MONTGOMERY COUNTY HISTORIC PRESERVATION COMMISSION STAFF REPORT

Address: 102 East Kirke Street, Chevy Chase **Meeting Date:** 7/10/2024

Permit No.: 1067931 REVISION **Staff:** Dan Bruechert

Proposal: Revisions to previously approved HAWP.

Figure 4: Revised site plans with the proposed fencing circled in green.

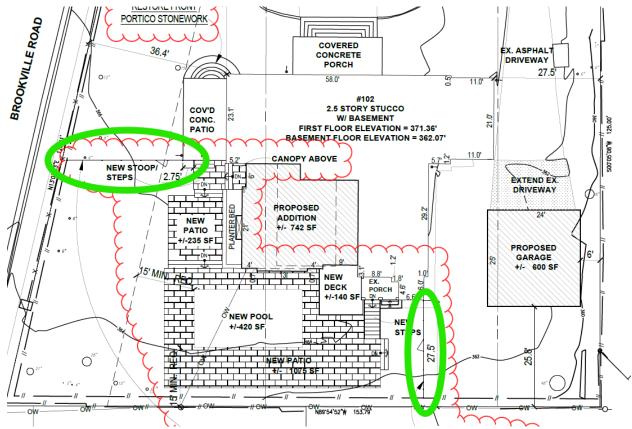
Staff finds the section of fence in the southeast corner of the property will not be at all visible from the right-of-way and finds the material and design are appropriate for the site and surrounding district and recommends the HPC approve it as a matter of course. Staff finds the section of fence to the west of the house is taller than what is typically desired – usually fences forward of the historic rear wall plane are limited to 48" (forty-eight inches) to preserve the open, park-like setting of the district. However, Staff finds the placement of this fence, at the rear of the historic porch has a rational basis that makes sense from a design perspective. Additionally, there needs to be a 5' (five-foot tall) fence enclosing the pool area to satisfy code. Finally, Staff finds the design of the fence is consistent with the privacy fence that runs along Brookville Rd. and Staff recommends the HPC approve the proposed fence on the west side of house.
